RE: Agreement No. 1945F
Project Number T202069012
Traffic Impact Study Services
Task 8A - Clifton Property

Johnson, Mirmiran and Thompson (JMT) has completed the review of the Traffic Impact Study (TIS) for Clifton Property prepared by Davis, Bowen & Friedel, Inc. (DBF) dated February 2020. This task was assigned as Task Number 8A. The report is prepared in a manner generally consistent with DelDOT's *Development Coordination Manual*.

General Information

Site Map

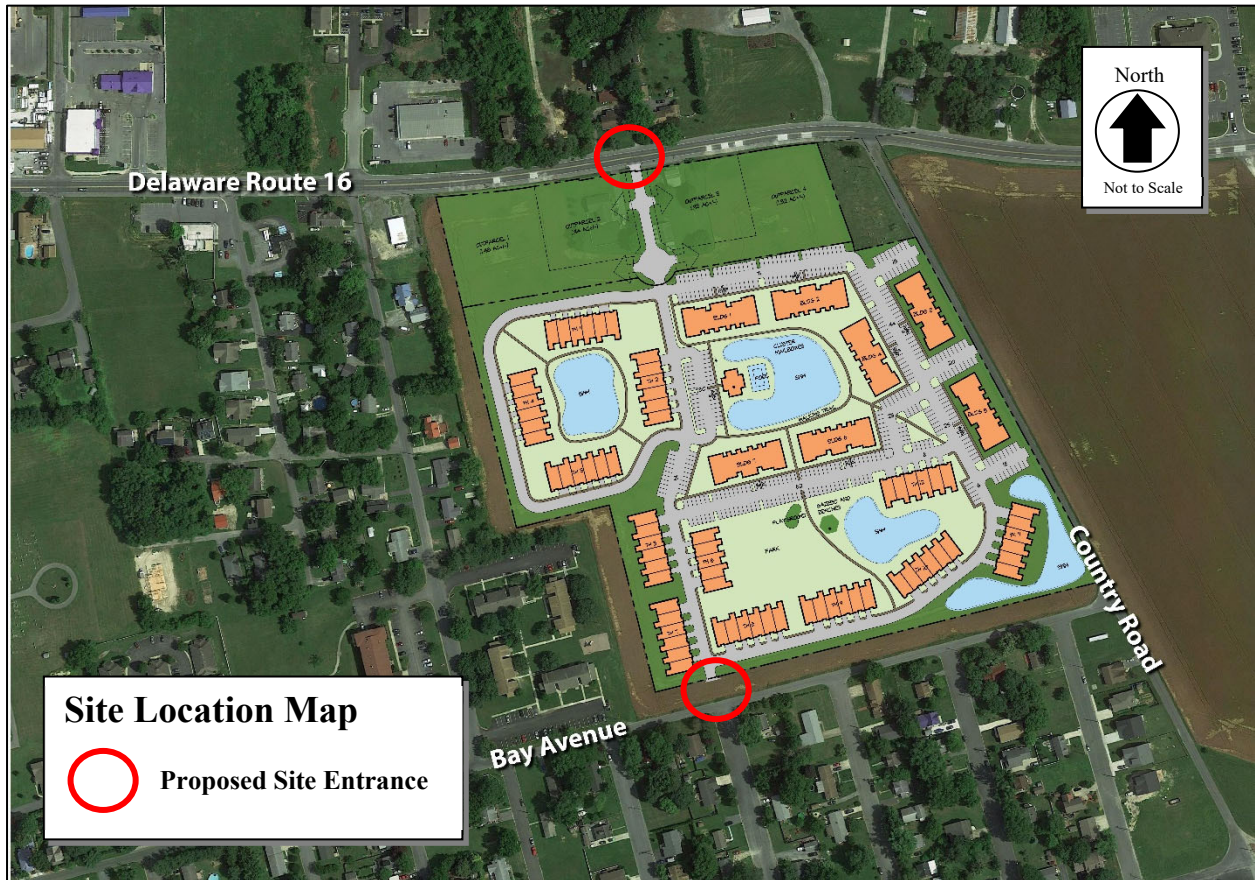
**Graphic is an approximation based on the Conceptual Site Plan prepared by Davis, Bowen & Friedel, Inc. dated December 19, 2019.*
